File #: SR 24-6, **Version:** 1

Reviewing request of Owner, Alex Delendik, to a Vacant Building Registration Notice at 827 AGATE STREET.

Project: Review of Constructed Retaining Wall
827 Agate St.
St. Paul, MN
PEC #6186

8" BLOCK WALL OPTION

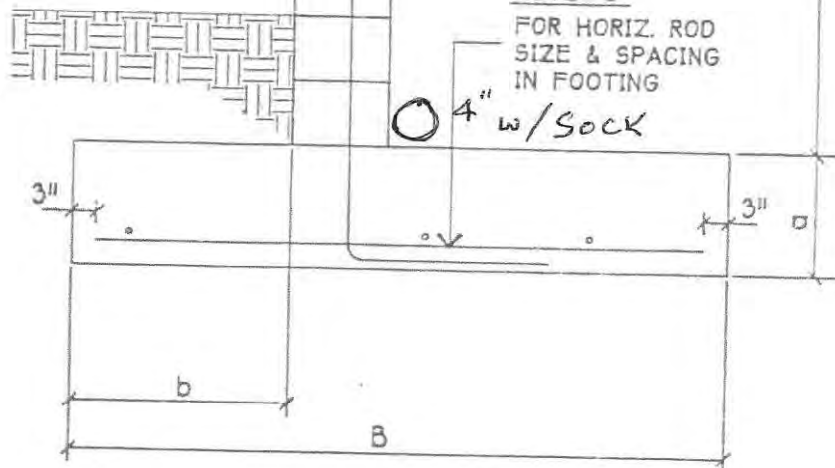
This report concerns our review of a constructed retaining wall behind the front sidewalk at 827 Agate St., St. Paul, MN. The property owner, Alexander Delendik, of Homestead Road LLC, performed his own construction of the wall in general conformance with a detail sheet entitled "8" Block Wall Option." However, the inspection department at the City of St. Paul required that the wall be inspected by a Registered Engineer who could answer to the construction requirements outlined in its identification sheet.

Over the last several weeks, the old retaining wall was demolished and the footing construction removed from the front stairway eastward to the east property line. This amounted to a retaining wall length of slightly less than 30', since a higher concrete retaining wall had been left in place to the west of the stairway. A new footing was dug in behind the sidewalk, providing a new footing which was approximately 12" deep and at least 32" from the existing front sidewalk toward the rear of the property. Reinforced concrete used ½" rebar for the longitudinal steel in three locations at the front of the footing, the rear of the footing, and half-way between these bars. The front and rear bars used a 3" cover of concrete to the dirt forms. The first course of 8" block was placed

in the wet concrete and the footing was stabbed with $\frac{1}{2}$ " bars spaced 20" on center toward the rear face of the concrete block first course.

Using this layout of block and rebar, successive courses of 8" concrete block, both double corner and common, were placed with a mason's mortar using a common bond pattern to top of wall height. The completed wall was approximately 4-1/2 courses in height. The vertical rebar were left at least 2 to 3" below top of wall. The completed wall section was then filled with a 4000 psi curb and gutter mix. The rear of the wall received a 4" corrugated drain tile with an exterior sock. The backfill material behind the wall was filled with a granular backfill material and then capped off with the natural excavated soils which consisted of a silty sand material with topsoil mix. The entire backfill region behind the wall was estimated as less than a 33% grade, and the entire backfill area received a grass mix and was covered by a straw mulch.

Since the entire project was completed just recently, the owner will also reseed in the springtime and will seed as needed for a grassy embankment. Based on our observations, the owner has protected the finished grade as much as possible and will continue with seeding and mulching this spring to establish a lawn. We informed the owner that such embankments should drain over the top of the wall and not behind the wall for maximum stability of the wall construction. It is our opinion the owner has used good workmanship on this construction.
